Title of Change:	Update for PB25146X - to include NTMFSC006N12MC and transition period
Effective date:	04 Jan 2023
Contact information:	Contact your local onsemi Sales Office or KrisJudelo.Dayna@onsemi.com
Type of notification:	This Product Bulletin is for notification purposes only. onsemi will proceed with implementation of this change upon publication of this Product Bulletin.
Change Category:	Marking
Change Sub-Category(s):	Shipping/Packaging/Marking

PB25146X specifies below, added NTMFSC006N12MC on impact list and transition period will be until Mar 31,2023.

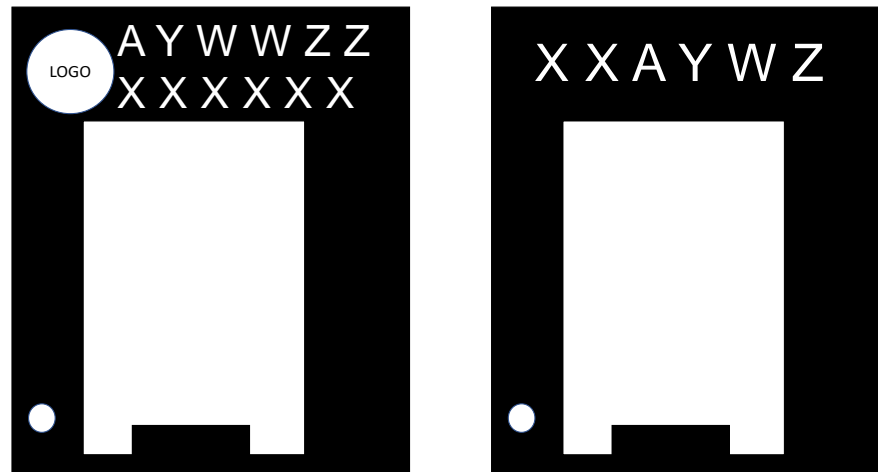
Character Measurement Change

From	To
A. Width	0.36 mm	0.41 mm
B. Length	0.47 mm	0.64 mm
C. Spacing	0.08 mm	0.19 mm
D. Index	0.05 mm	NA

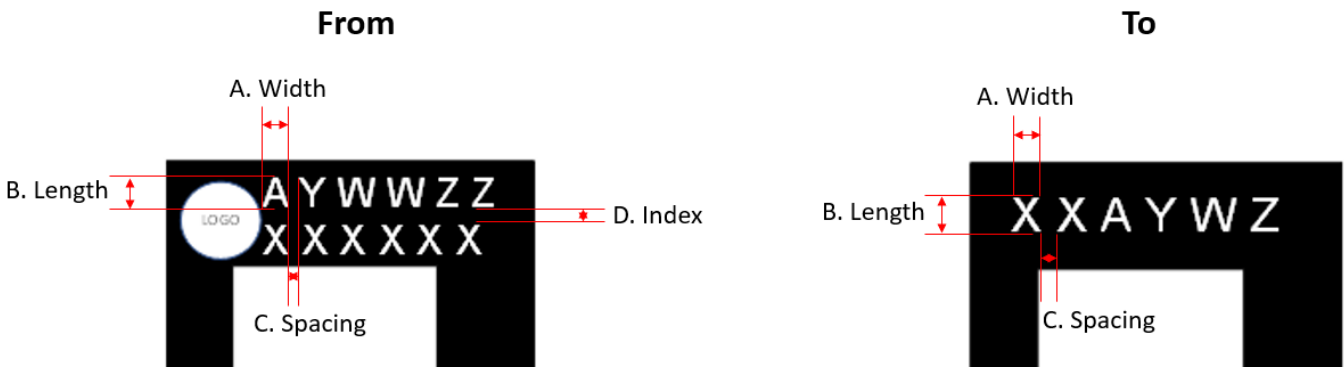
In order to improve quality of marking and its legibility. We are moving towards simplification of the layout.
Below is the summary of the changes.

Existing Layout	New Layout
Logo	Yes	No
Plant Code	Yes (A)	Yes (A)
Date Code	Yes (YWW)	Yes (YW)
Lot Code	Yes (ZZ)	Yes (Z)
Device Mark	Yes (XXXXXX)	Yes (XX)

Please note that "ON" logo will be removed on the new layout.

ZZ – 2 digit lot code sequence per starts with AA, AB, AC, AD, etc
Z – 1 digit lot code sequence starts with A, B, C, D, etc.

OPN	Existing Mark	New Mark
FDMS7650DC	7650	2F
FDMS8320LDC	8320L	2G
FDMS86101DC	86101	2H
FDMS86200DC	86200	2J
FDMS86300DC	86300	2K
FDMS86500DC	86500	2L
NTMFSC004N08MC	4N08MC	3F
NTMFSC010N08M7	10N8M7	3G
NTMFSC011N08M7	11N8M7	3H
NTMFSC012N15MC	12N15M	3J
NTMFSC0D9N04CL	410LDC	3K
NTMFSC1D0N04HL	1D0N04	3L
NTMFSC1D6N06CL	612LDC	3M
NTMFSC1D9N06HL	1D9N06	3N
NTMFSC2D9N08H	2D9N08	3P
NTMFSC4D2N10MC	4D2N10	3Q
NVMFSC0D9N04C	410NDC	4F
NVMFSC0D9N04CL	410LVC	4G
NVMFSC1D6N06CL	612VDC	4H
STMFSC008N10M5	86101	2H
STMFSC017N15M5	86200	2J
STMFSC3D1N08M7	86300	2K
NTMFSC006N12MC	06N12M	3R
